Access Compliance Report Public Rights-of-Way (Curb Ramps)

Main Street: E_PEARL_ST Cross Street: EARLHAM_ST Location: SE

ADA ID: RPAT210927132544 Ramp Type: Type 4 - Parallel Initial Pass/Fail: Fail Overall Compliance: No Severity Score: 19

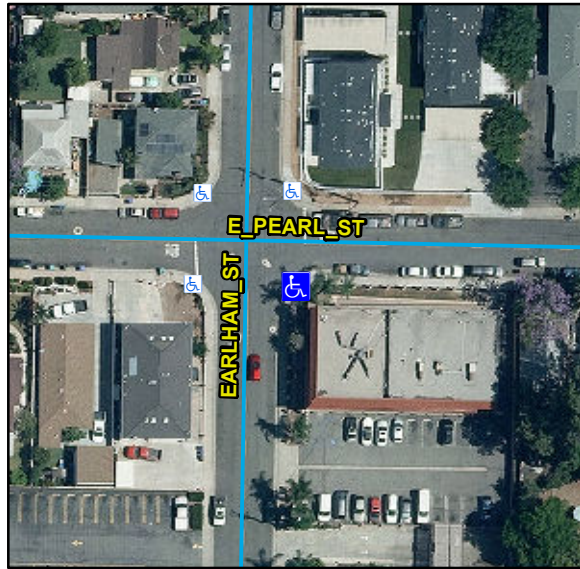
Compliance	Description	Data	Compliance	Description	Data
N/A	Ramp Length LT (in)	88	N/A	Ramp Length RT (in)	93
No	Ramp Width LT (in)	47	Yes	Ramp Width RT (in)	48
No	Ramp Run Slope LT (%)	10	Yes	Ramp Run Slope RT (%)	4.5
Yes	Ramp Cross Slope LT (%)	0.5	Yes	Ramp Cross Slope RT (%)	0.6
N/A	Landing Present	N/A	N/A	DWS Provided	N/A
N/A	Landing Length (in)	N/A	N/A	DWS Contrast	N/A
N/A	Landing Width (in)	N/A	N/A	DWS Length (in)	N/A
N/A	Landing Run Slope (%)	N/A	N/A	DWS Full Width	N/A
N/A	Landing Cross Slope (%)	N/A		DWS Offset Type	N/A
N/A	Landing Movement Obstructed?	N/A	N/A	DWS Offset Left (in)	N/A
	Landing Movement Type	N/A	N/A	DWS Offset Right (in)	N/A
N/A	Landing Shared	N/A			
N/A	Clear Space	Yes			
N/A	Clear Space To Crosswalk (in)	N/A			
N/A	Marked Crosswalk 1	No	N/A	Marked Crosswalk 2	No
	Crossing 1 Direction	N		Crossing 2 Direction	W
	Marked Crosswalk 1 Width (in)	N/A		Marked Crosswalk 2 Width (in)	N/A
N/A	Ramp Inside Crosswalk 1	N/A	N/A	Ramp Inside Crosswalk 2	N/A

Remove & Replace Curb Ramp With Two New Directional Ramps or Equivalent.

R304.5.1, R304.3.2, STD 1115
